VIBRATION/SHAKE—AT STEADY SPEED APPROXIMATELY 100 KM/H (62 MPH)—VEHICLES WITH 4.6L ENGINE AND CONVERTIBLE TOP	Article No. 00-9-7
--	-------------------------------

FORD: 1996-1998 MUSTANG

Figure 1 - Article 00-9-7

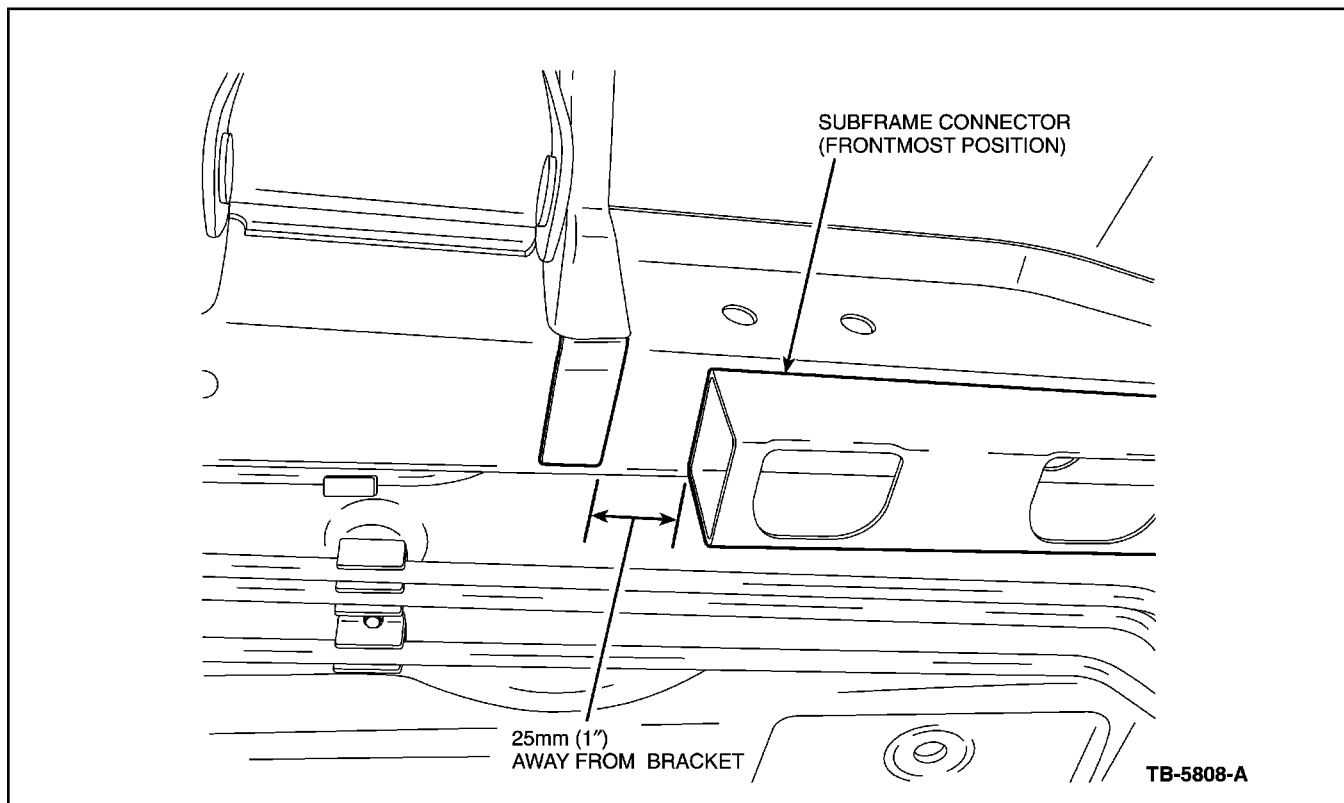
10. Install a set of Underbody Rails (XR3Z-76101W09-AA - Left and XR3Z-76101W08-AA - Right). Refer to Figure 1 to determine where to place the rails to the underbody. The underbody rails will need to be welded to the underbody of the vehicle by referring to the following:

Figure 2 - Article 00-9-7

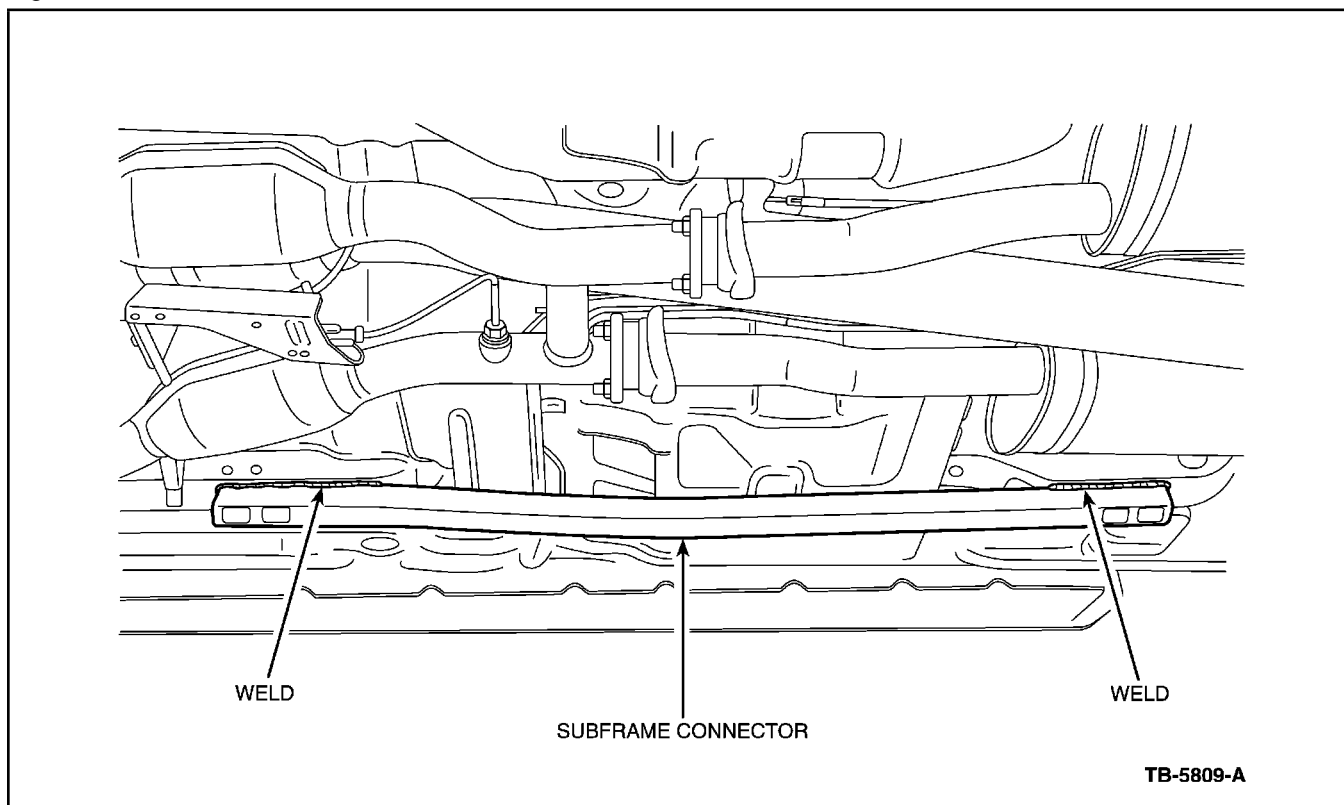
- The welds should have a minimum 5mm weld bead and a minimum total length of 75mm on both sides of the rail and at both front and rear ends (Figure 2).
